Bulletin No.	TS79-022
Date	April 6, 1979
Classification	3E79-003
Section	Body Electrical
Models	280-ZX

BATTERY SENSOR, 280-ZX

280-ZX Battery Sensor Substitute

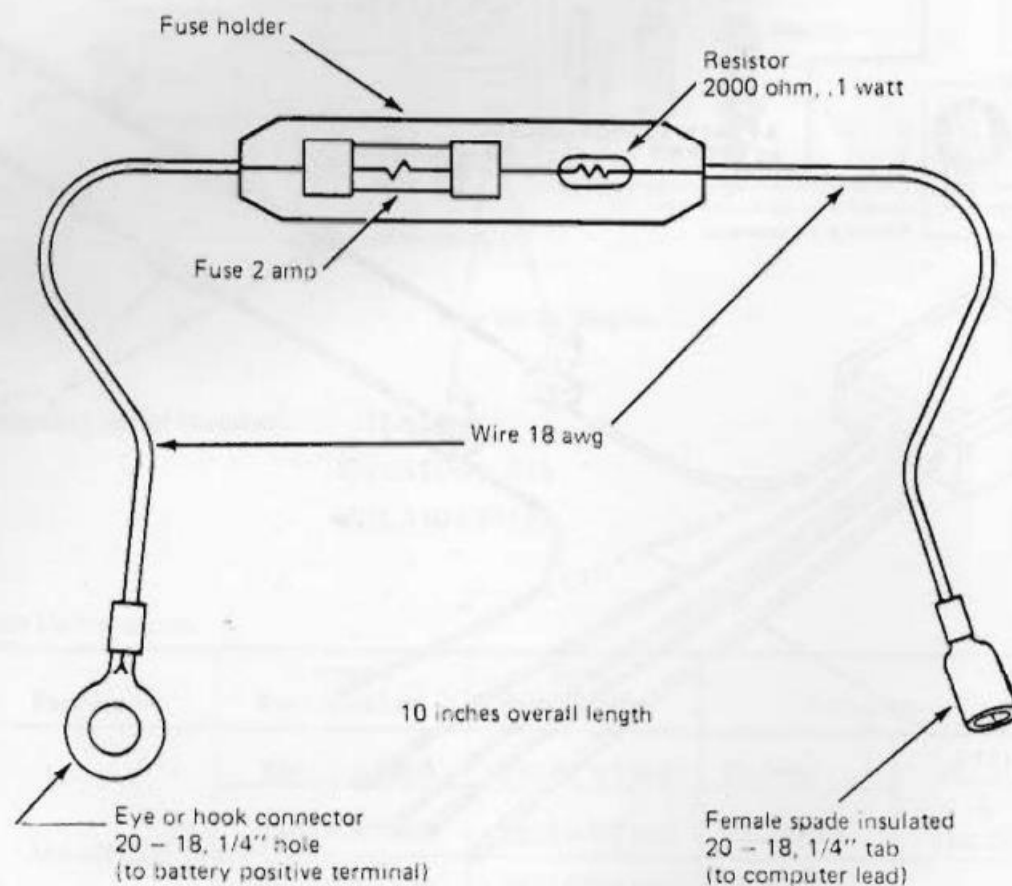
If a low maintenance battery (P/N 99996-00026), without openings to add water is installed, it will be necessary to fabricate and install the battery sensor substitute illustrated below for the computer warning system to function properly.

Materials (local purchase): Fuse holder
 Fuse, 2 amp
 Resistor, 2000 ohm, 0.1 watt
 Eye connector, 20-18, 1/4"
 1/4" spade connector, female, insulated
 Wire, 10" 18 gauge
